**De Zavala Elevated Storage Tank Project
Solicitation Number: CO-00409-FG
Job No.: 15-6001**

**ADDENDUM 2
August 18, 2021**

REF. NO. C-04R △
SHEET 9R OF 65

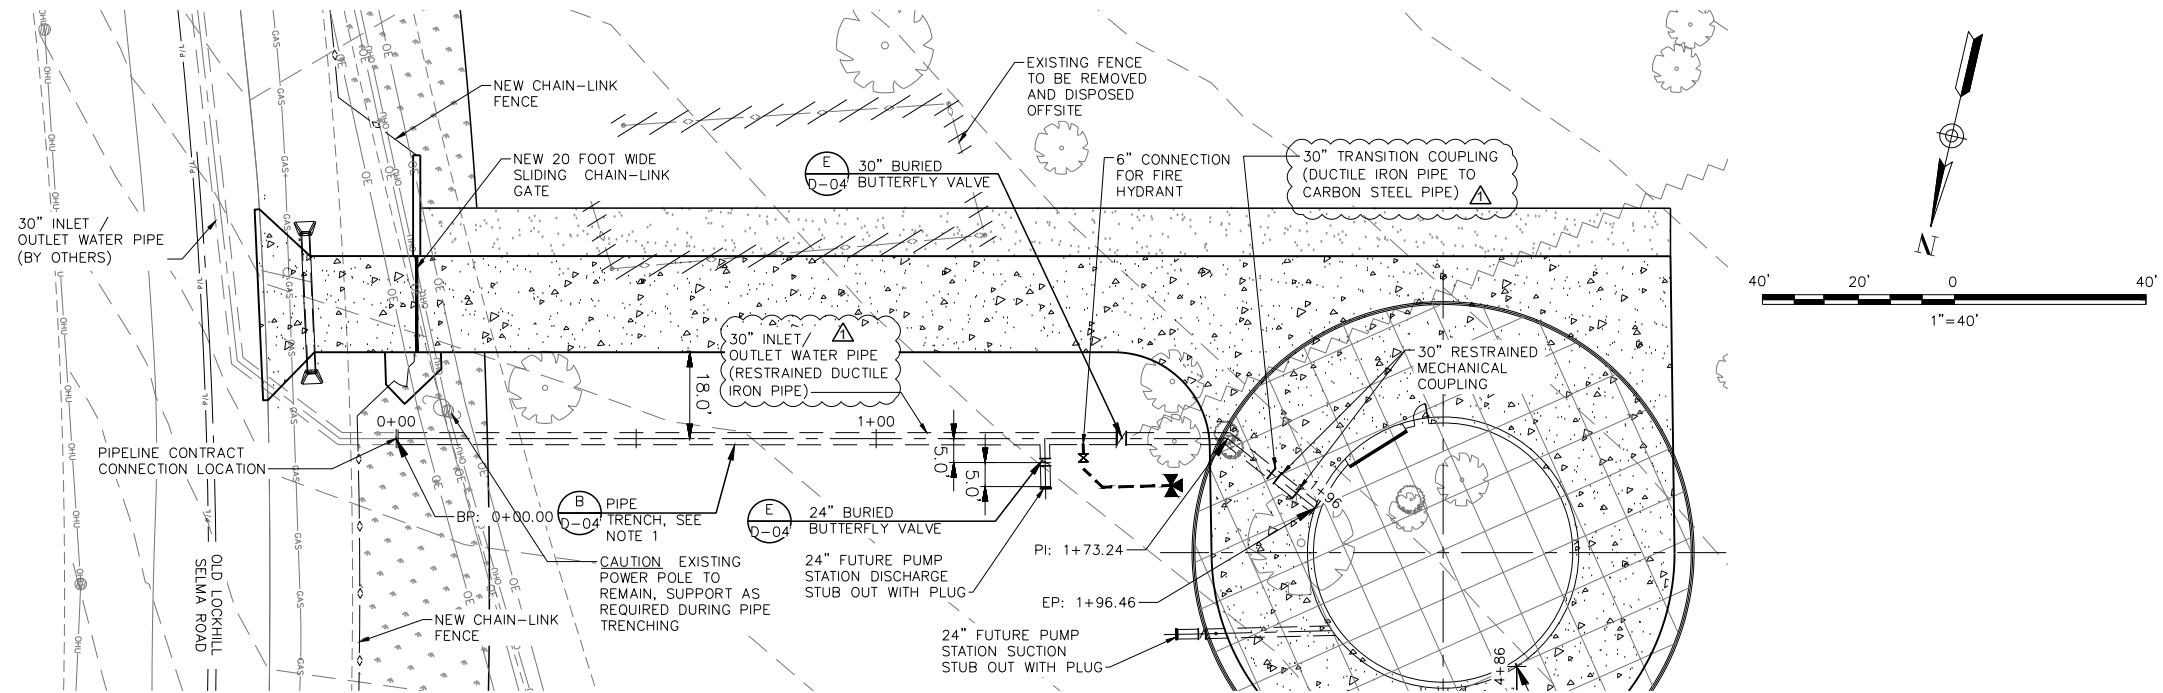
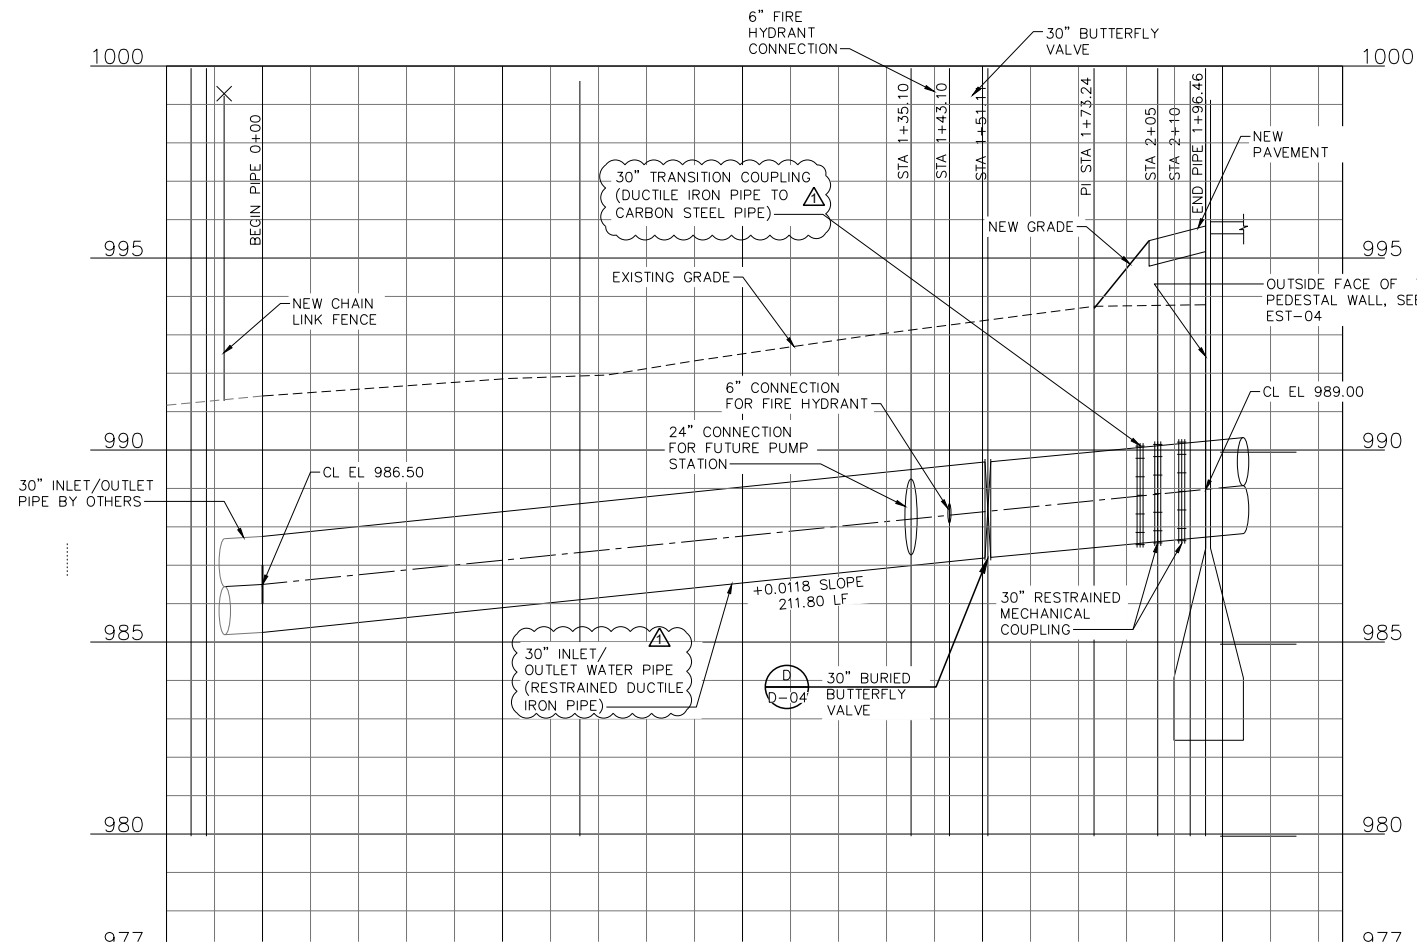
- Response: *See previous response to Question #17 clarifying pipeline materials.*
37. Question: Section 33 16 11 Item 2.06.L.1 specifies the piping below the grade slab as flanged cement lined steel (ductile iron). However, the drawings show fully welded carbon steel piping. Industry standard is typically ductile iron. Please confirm the piping below the grade slab can be either ductile iron or carbon steel.

- Response: *Below grade piping shall transition from carbon steel to ductile iron as shown the modified design drawings. Refer to "Changes to Plans" section as included with this addendum.*

- Response: *No, a cathodic protection system will not be required since the 30" inlet/outlet pipeline has been modified via this addendum to ductile iron pipe material in accordance with SAWS Construction Specifications.*

REF. NO. EST-03R △
SHEET 15R OF 65

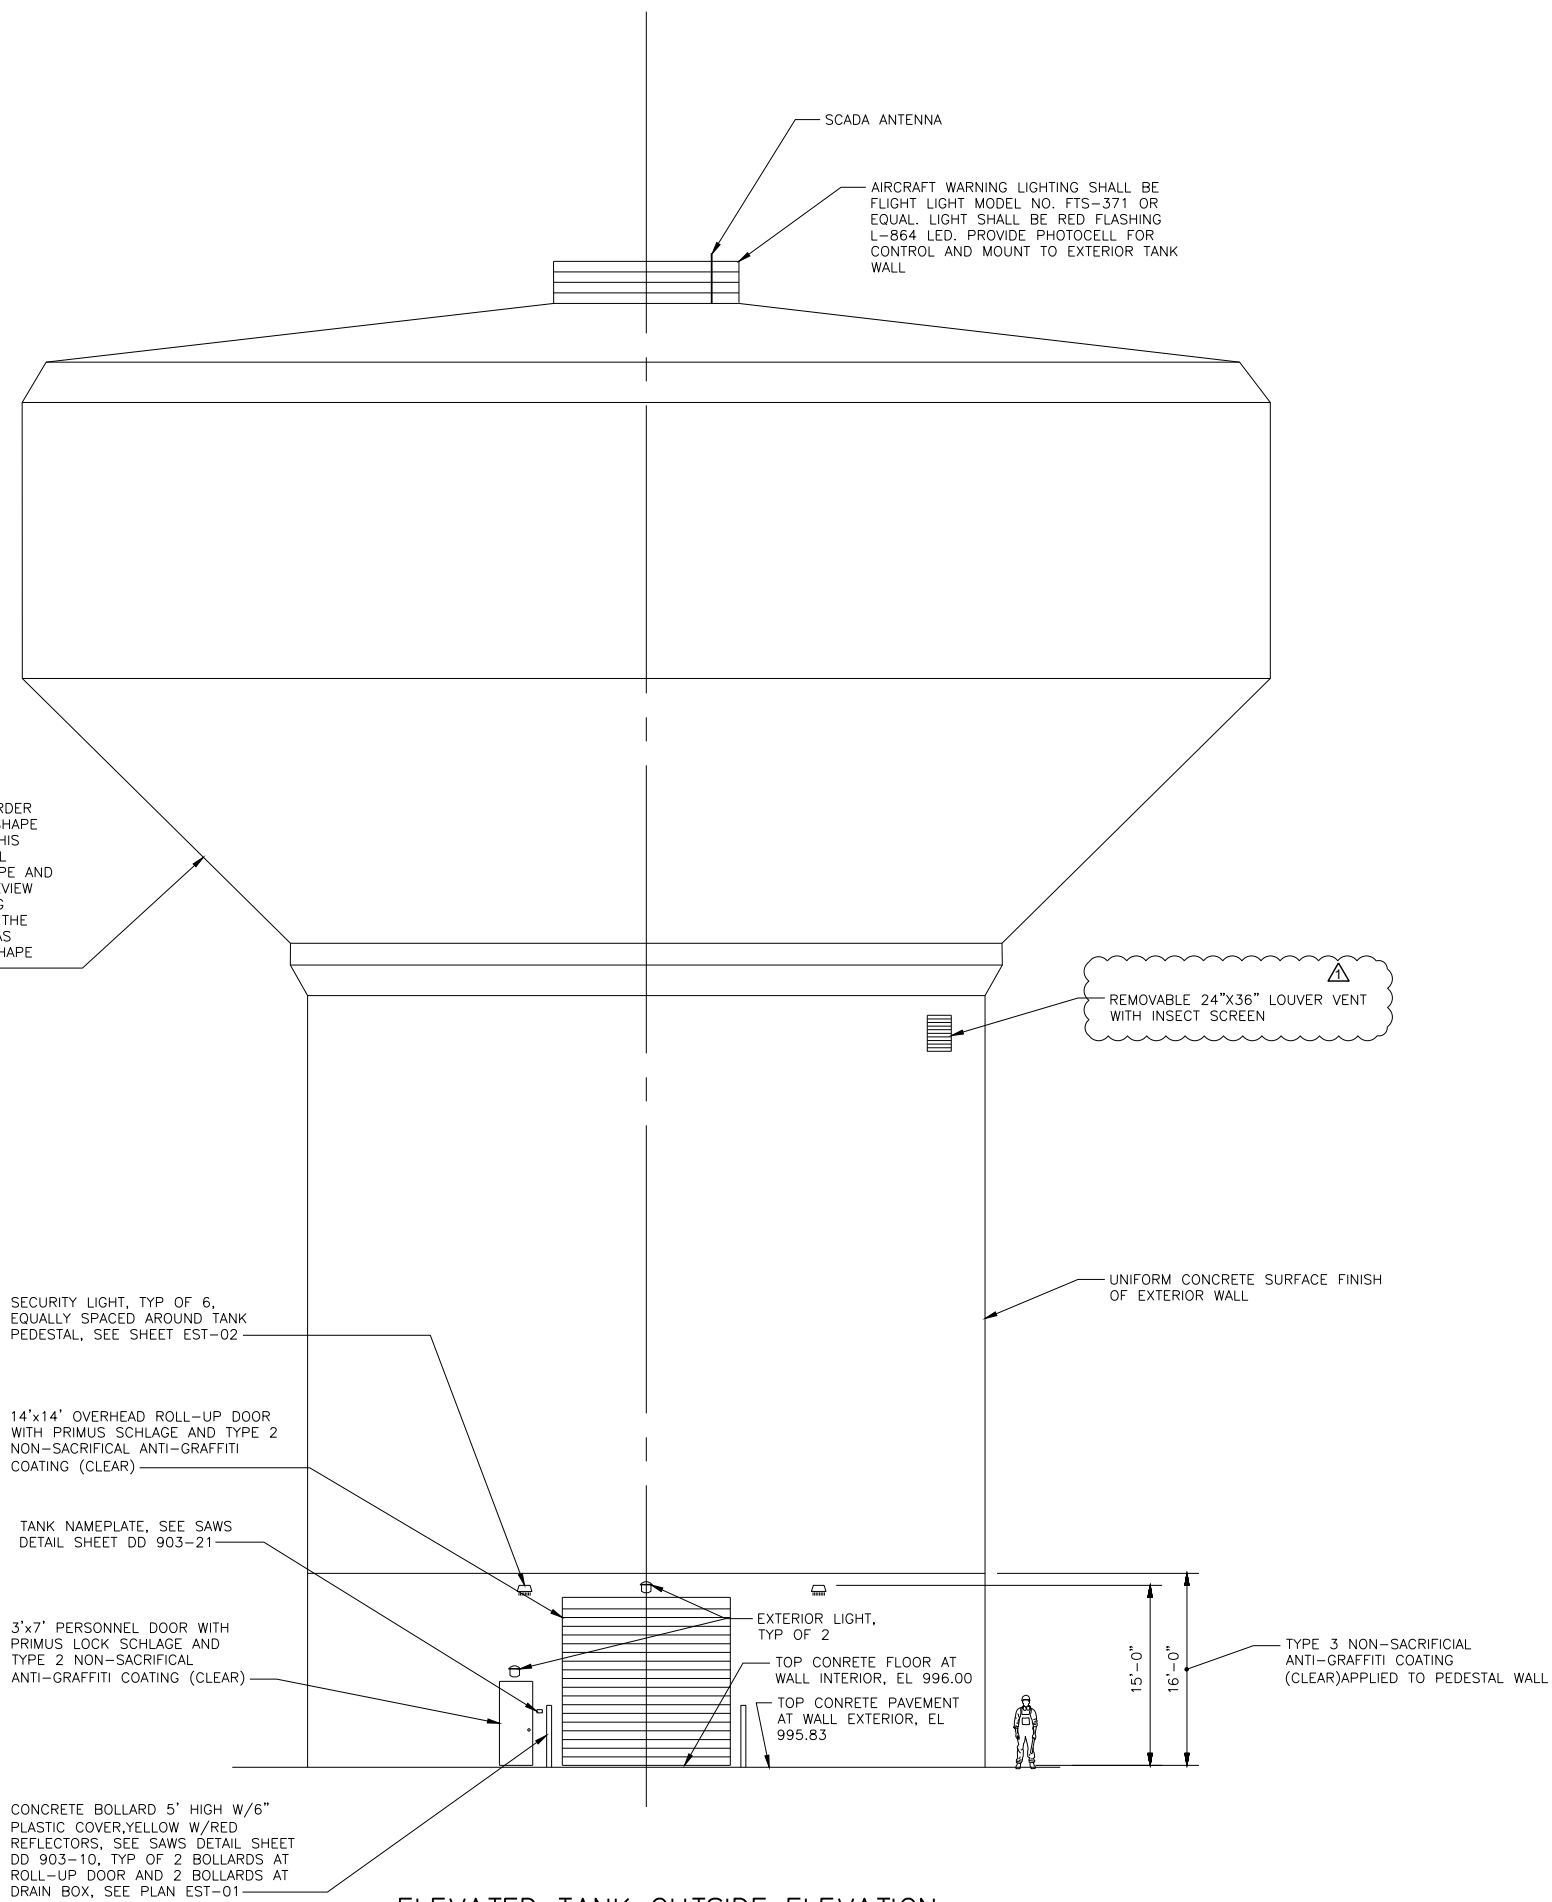
11. Question: Tank Spec 33 16 11-10 Item 2.06.J.1 requires a 36"x42" vent opening at the top of the support wall. Our standard louvered vent at the top of the wall is 24"x36" and is detailed to be accessible from the ladder platform/walkway, and provide safe access to the exterior painters rail. If more ventilation area is required, will two 24"x36" standard louvered vents be acceptable?

30. Question: Sheet 15 shows an “upper return” at the intersection of the tank side wall and the tank roof, however It is not described or dimensioned on the drawings or in Section 33 16 11. Is an upper return required? If required, we suggest the industry standard dimension of 1’-6” H / 2’-6” V.

Response: *Yes, Technical Specification 33 16 11-10 Item 2.06.J.1 has been modified to reflect vent opening with 24"x36". Refer to "Modification to Specifications" section as included herein/below. Also refer to "Changes to Plans" (Design Drawing EST-03, Sheet 15 of 65) section as included with this addendum.*

Response: *Yes, and industry standard return dimension of 1’-6” H / 2’-6” V is acceptable.*

1. Hach
 2. Approved Equal”
3. Amend Technical Specification 33 16 11-10 Item 2.06.J.1: REPLACE reference to 36”X42” vent opening with 24”x36”.
4. Amend Technical Specification 33 06 05-1 Item 2.01.C: REPLACE reference to “...30-inch Outlet Line (PZ 1170)...” WITH “...24-inch Outlet Line (PZ 1170)...”
